INFORMATION FLASH

SALES DIVISION
NETWORK TECHNICAL INFORMATION

FOX

Subject: WORN OUT SPARK PLUG

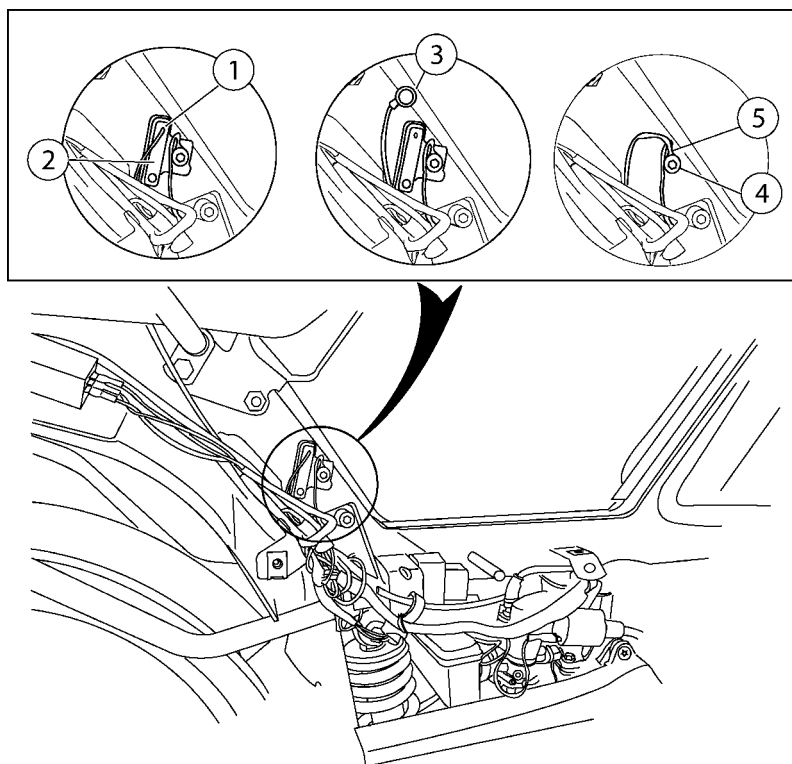
Engine does not start, the spark plug is worn out.

Under certain riding circumstances, such as door-to-door deliveries, it might be necessary to modify the vehicle. In this case and only in this case, replace the original spark plug with a BPR6HS spark plug **P/N 735592** and suppress the choke control resistor.

Remove the lower right and rear right fairings.

Cut the wire (1) level with the choke control resistor (2) and crimp a round 6.5 mm diameter terminal (3) **P/N 725364** on the wire.

Remove the screw (4) and suppress the choke control resistor (2).

Re-install the screw (4) while inserting the two round terminals (3) et (5).
